RE: Radiological Characterization of the Shieldalloy
Metallurgical Corporation Newfield Facility

**WORK PLAN FOR THE
RADIOLOGICAL
CHARACTERIZATION OF
THE SHIELDALLOY
METALLURGICAL
CORPORATION
NEWFIELD FACILITY**

NJ DEP COMMENTS TO RADIOLOGICAL WORK PLAN

Re: Work Plan for the Radiological Characterization of the
Shieldalloy Metallurgical Corporation Newfield Facility
June 1990

FIGURE 1-1

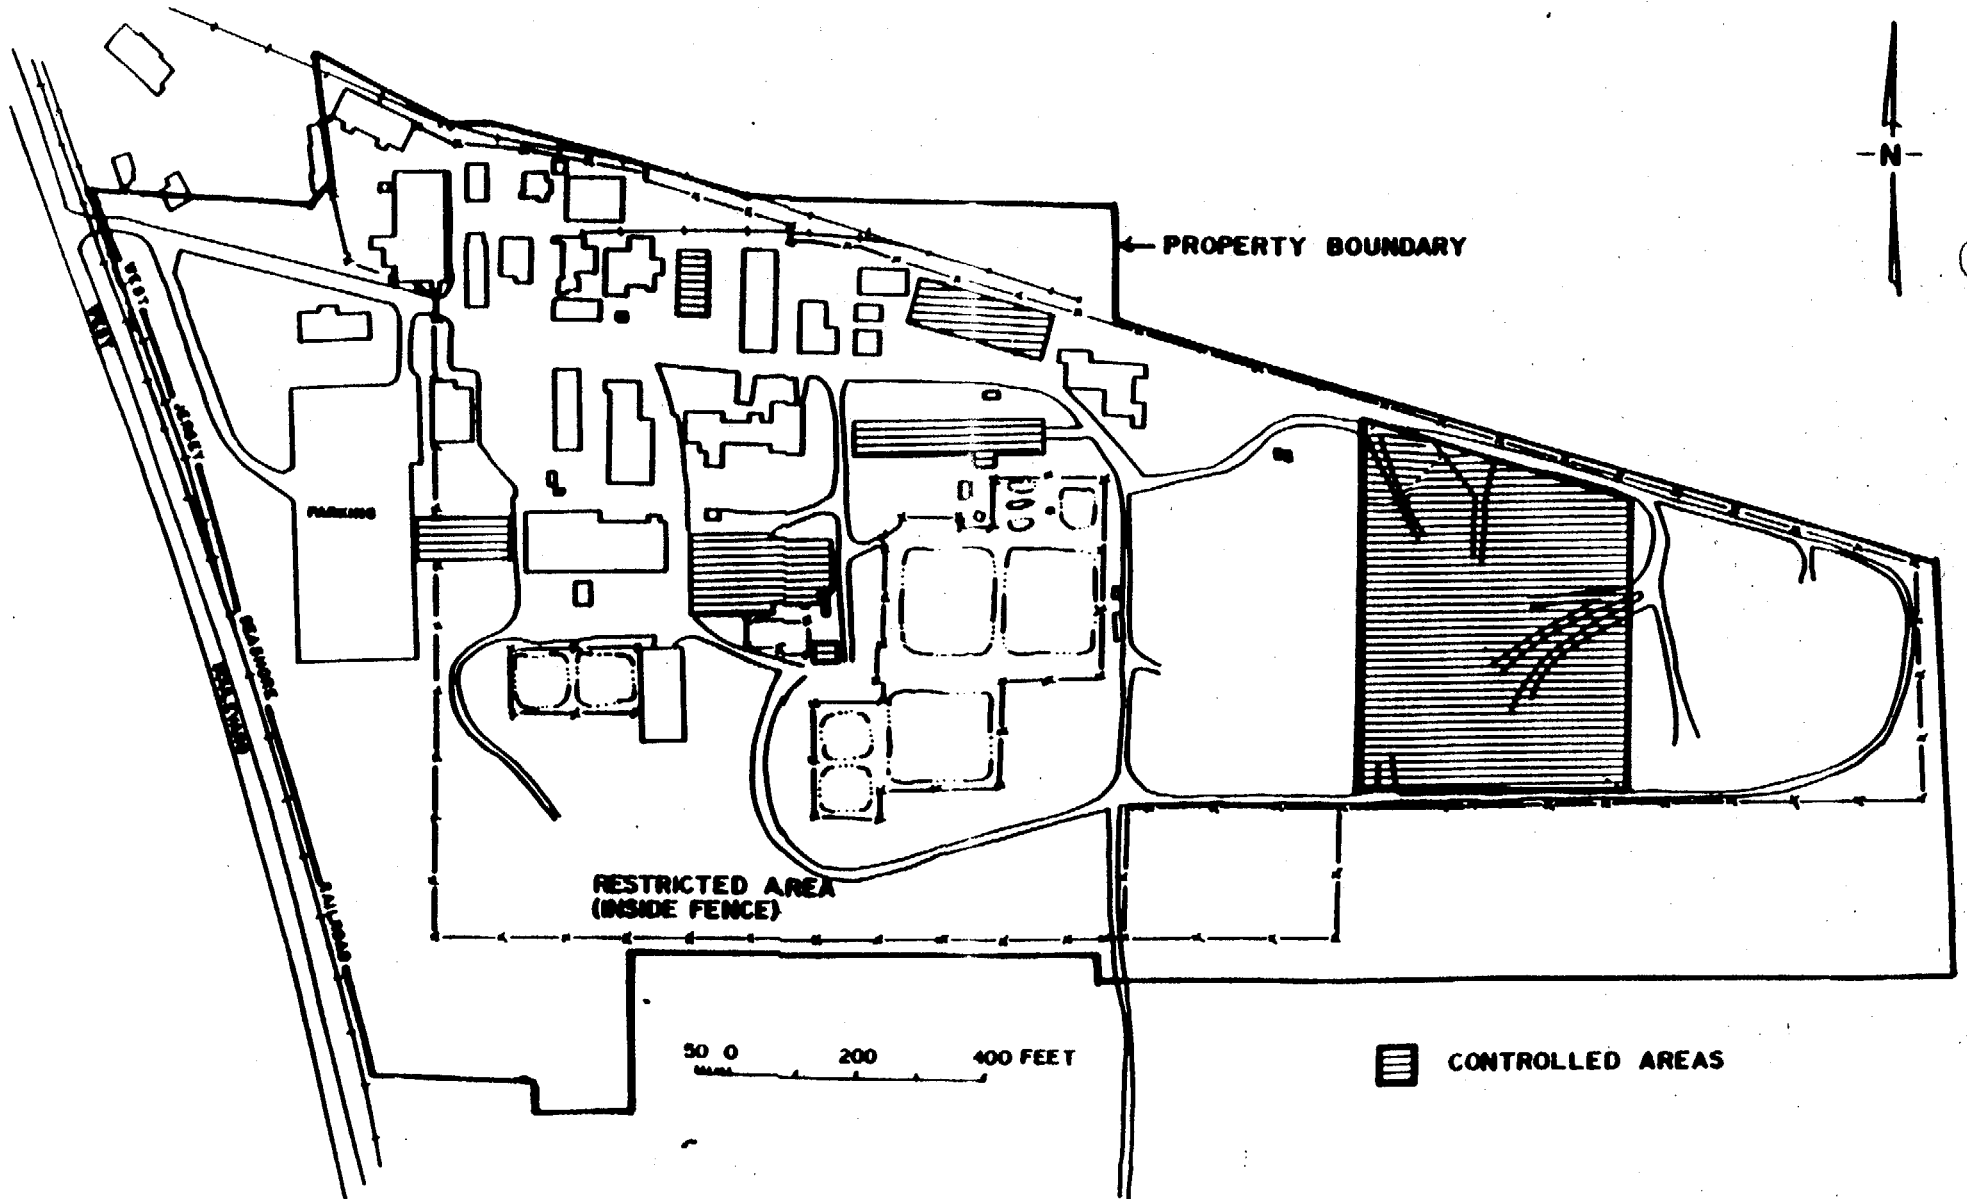
The grid system shall cover the entire property owned by SMC, not only the area 30 meters beyond the existing facility fence line as proposed. The proposed survey area consists of two grid systems which include the area extending 30 meters beyond the fence line and the area extending 20 meters on each side of the stream (Hudson Branch). It is assumed that these two grid systems overlap, providing the required coverage, however, the scale and level of detail in Figures

1-1 and 2-2 is insufficient to make the appropriate comparisons. Therefore, a figure of sufficient scale shall be provided which accurately shows the location of the stream in relation to the fenceline and property boundaries, and the complete survey area.
